Staff Report

Infill Housing Design Review Committee

File Number: 8-C-23-IH

Location: 1719 Texas Ave. **Parcel ID** 81 P D 031
Zoning: RN-2 (Single-Family Residential Neighborhood)
District: Lonsdale Infill Housing Overlay District

LeMAY & ASSOCIATES CONSULTING ENGINEERS 10816 KINGSTON PIKE KNOXVILLE, TN. 37934 PH: 865-671-0183	PLOT PLAN LOTS 13 & 14 LONSDALE ADDITION 1719-1713 TEXAS AVE. KNOXVILLE, TN 37921		DATE: 7-20-2023
			SCALE: 1" = 30'
			DWG. NO. 6304
			DRAWN BY: RELjr.

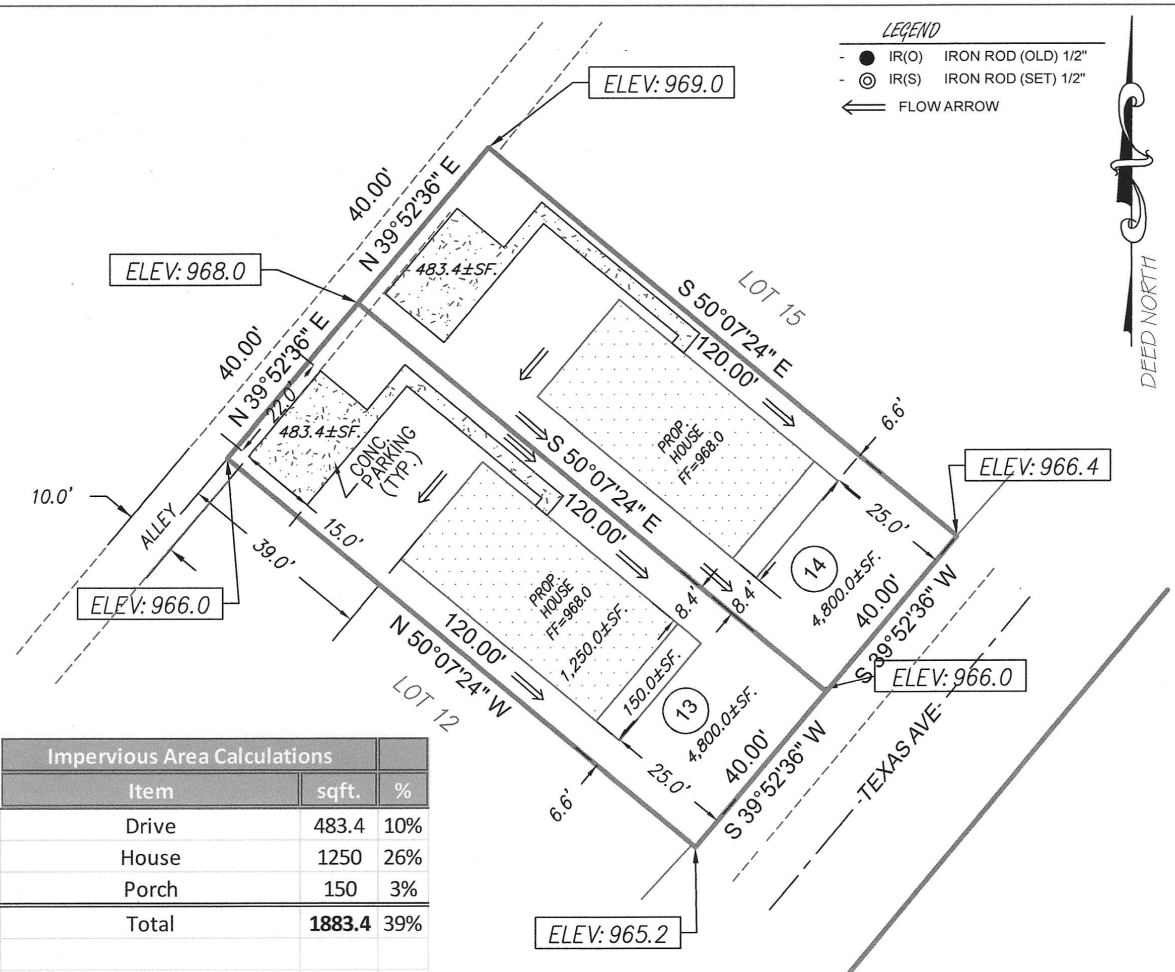
1. The edge of the front porch is proposed to be set 25' from the front property line so the main massing of the house will be set 33' from the front property line. The average front setback of the block is 24.5', also measuring to full-length front porches on the houses. The new house's front setback will maintain a consistent streetscape pattern with houses on the block. The final site plan should include a walkway to the street.

3. The proposed parking meets Infill Housing design guidelines as the parking pad is accessed from the alley and located to the rear of the house. Final revisions to the site plan may be necessary to meet City Engineering standards.

9. The final site plan should indicate one new native or naturalized shade tree to be planted in both front and rear yards.
10. The house is proposed to be identical to the adjacent new construction house at 1723 Texas Ave (8-D-23-IH). Revisions should be made to the two houses to introduce differentiation in design; options include revised rooflines, porch design and placement, or house massing.

Staff recommends approval of Certificate 8-C-23-IH, subject to the following conditions: 1) final site plan to meet City Engineering standards; 2) foundation to reflect foundation height of existing houses on block and be clad in stucco; 3) final siding materials to meet Infill Housing design guidelines; 4) revisions to placement of side elevation windows, with approval by staff; 5) revisions to differentiate from adjacent new house at 1723 Texas Avenue, with approval by staff.

EXTERIOR ELEVATIONS

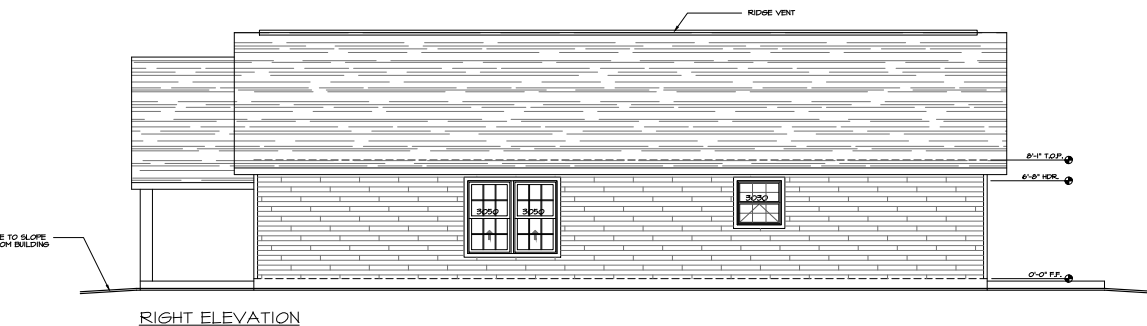
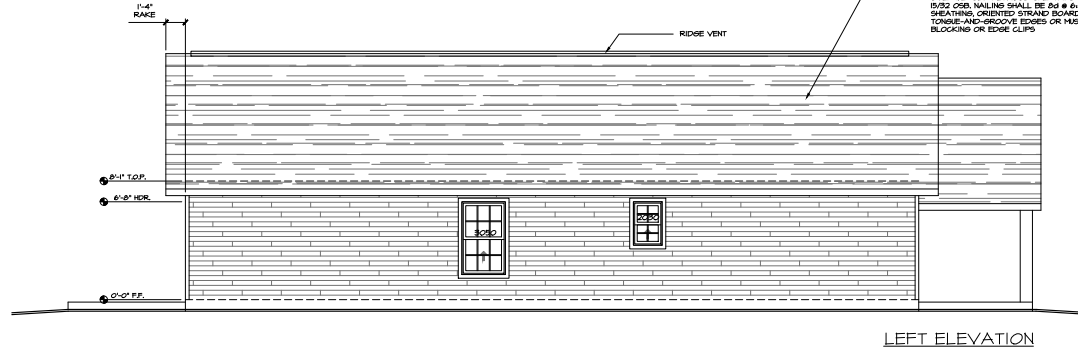
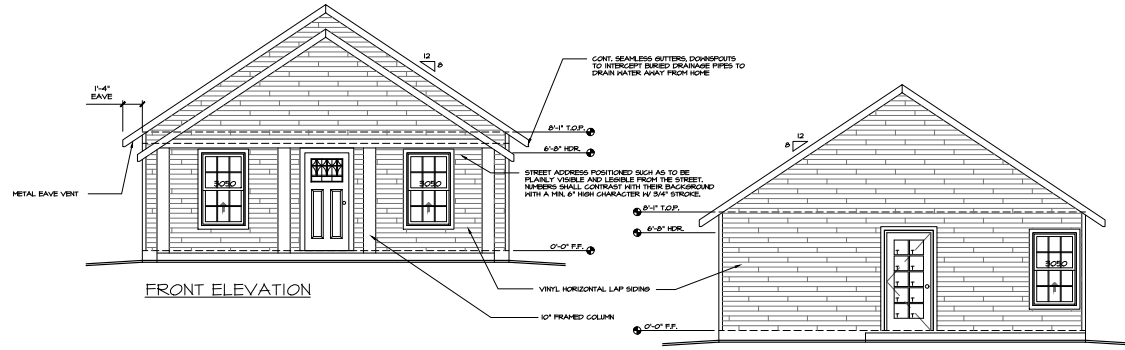
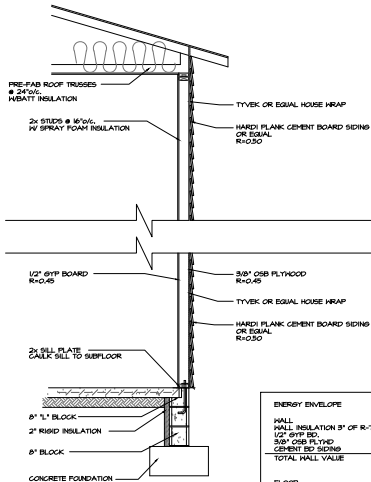
4. Overall, the one-story, three-bay façade is similar in scale to the context. The foundation height should be confirmed to be compatible with the neighborhood.

6. Guidelines recommend window and door styles be similar, with similar proportions and ratio of solid to void, to historic houses on the block. The proportions of windows and door on the façade meet the guidelines. Revisions are necessary to side elevation window placement to avoid large swaths of siding with no transparency.

7. The proposed roof pitch and material are appropriate within the guidelines.
8. The elevation drawings do not specify a siding material. The applicant should specify siding materials, referring to page 13 of the Infill Housing Design Guidelines.
